HARTZELL PROPELLER INC.
SERVICE BULLETIN
TRANSMITTAL SHEET
HC-SB-61-304

Propeller - Introduction of an Improved Blade

August 1, 2012

This revision is issued to change the following in the Service Bulletin:

Figure 1

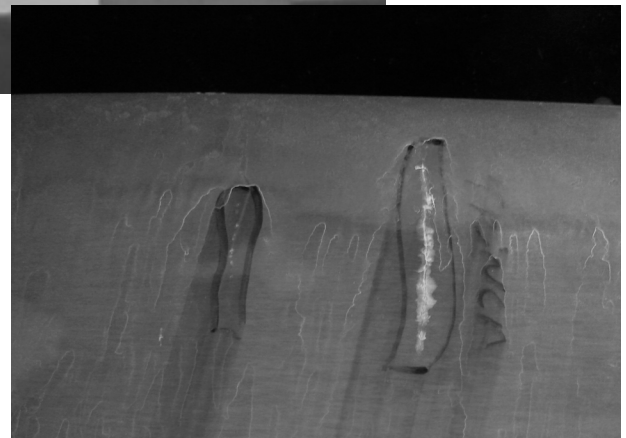
- (1) There have been sporadic reports of blade flutter during landing while using propeller reversing. An investigation identified a greater likelihood for this occurrence with blades nearing dimensional minimums.
 - (a) This same occurrence of blade flutter is also possible with blades near original manufacturing specifications.
 - (b) This condition can cause cracked and/or failed blades. Refer to Figure 1.

Cracks are located between the markings on the blades shown.

Examples of Cracked Blades Caused by this Condition

- (2) Blade Flutter can be identified by a large increase in sound level during application of reverse.
- (3) Blade replacement in accordance with the Compliance section of this Service Bulletin will minimize the tendency for flutter.
- (4) Replacement of all T10173F(N)(B,K)-12.5 blades with improved T10173AN(B,K)-12.5 blades is terminating action for this Service Bulletin.
- (5) Regulatory action is unknown.

Blade Butt Showing Damage to Prevent Further Use of the Blade
Figure 2

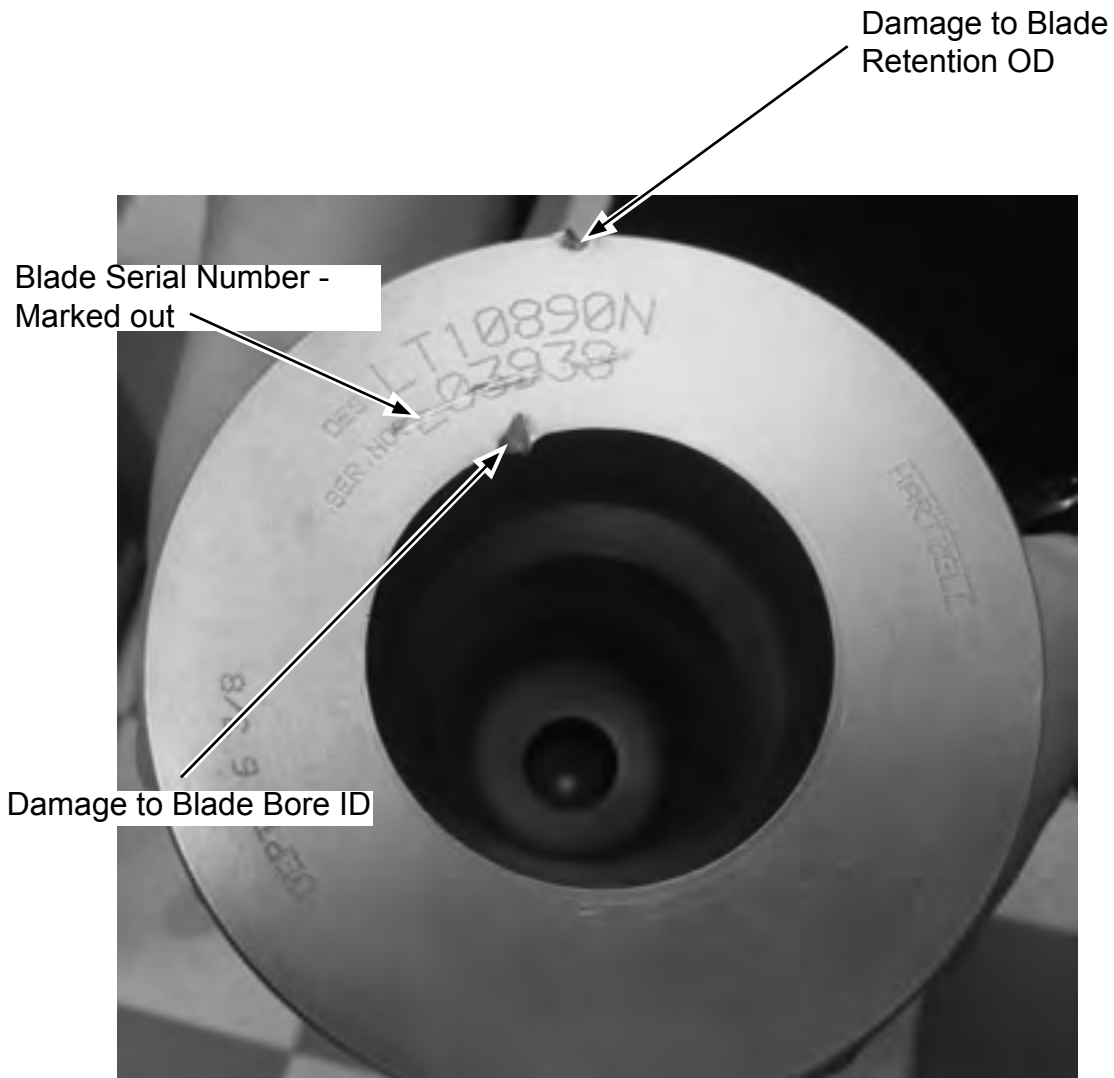
Note: The blade shown is not an affected blade. This blade is shown as an example only of the damage that should be made to retire the blade.

- 1 The retired blades cannot be modified or returned to service for use in any application, including experimental applications.
- 2 Each blade must be damaged in such a way that prevents further use of the blade.
 - 1 Using a tool, damage the ID of the blade bore and the OD of the blade retention surface. Damage must be sufficient to prevent installation of the blade bearing and the blade clamp. Refer to Figure 2.
 - 2 Mark out the blade serial number, so that the number is still legible.
 - 3 Take a photograph of the blade butt to show the damage, the blade model number, and the blade serial number. Refer to Figure 2.
 - 4 Send the photo via email to techsupport@hartzellprop.com in accordance with the Appendix to this Service Bulletin. **DO NOT RETURN THE BLADE.**
